Access Compliance Report

Public Rights-of-Way

(Curb Ramps)

Intersection ID: 23459	Main Street: ALEXANDER_RD	Cross Street: GARDNER_LN	Location: NW
ADA ID: 6D08CDA905A9	Ramp Type: BlendTrans1	Initial Pass/Fail: Fail	Overall Compliance: No
Severity Score: 1.25			
Codes/Mitigation Info/Possible Solution		Field Measurements/Component Compliance

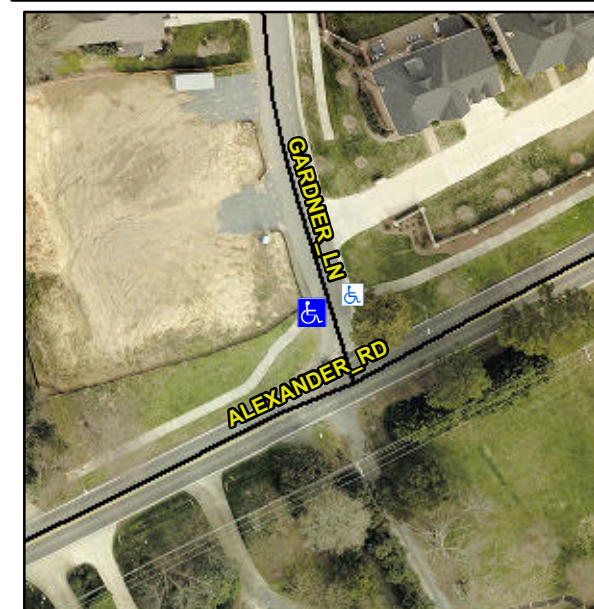
Remove & Replace Curb Ramp With Two New Directional Ramps or Equivalent.

R304.5.3
